Lower Penitencia Creek Improvements Project

Final Environmental Impact Report

VOLUME 1: RESPONSE TO COMMENTS ON THE DRAFT EIR

October 2017

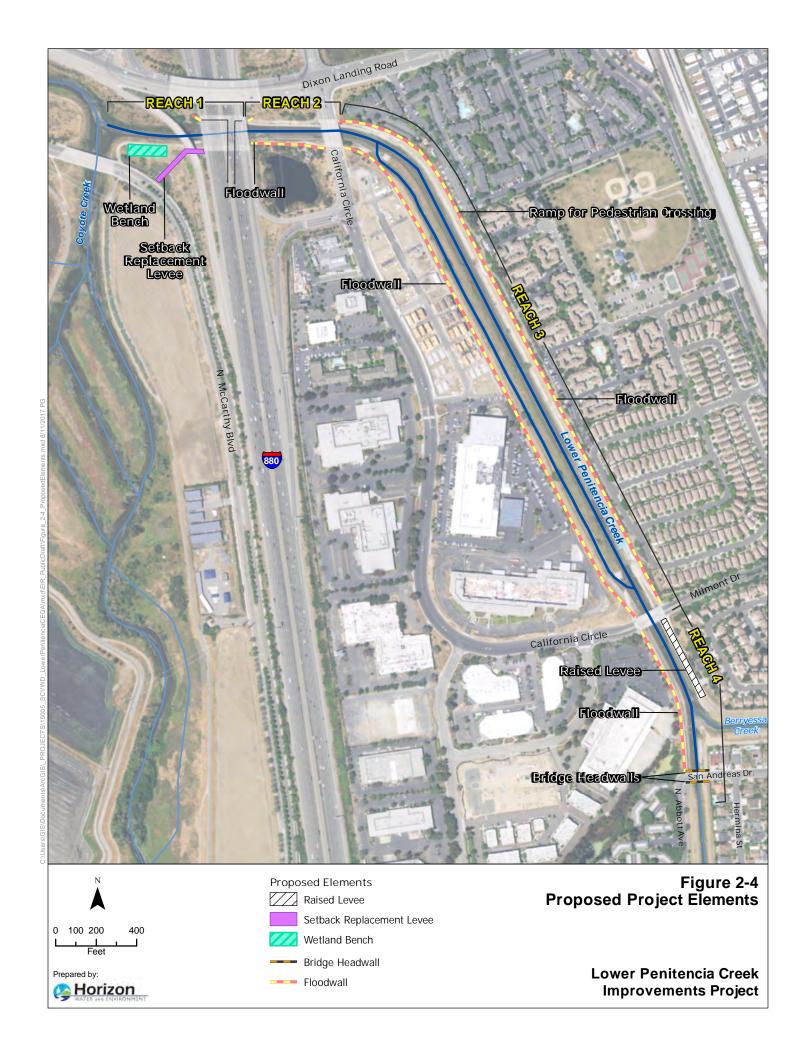
To incorporate the project description changes described above under the heading "Revisions to Executive Summary," Figure 2-4 on DEIR page 2-11 has been revised to show the two new segments of floodwall near I-880. The revised figure is shown on the following page.
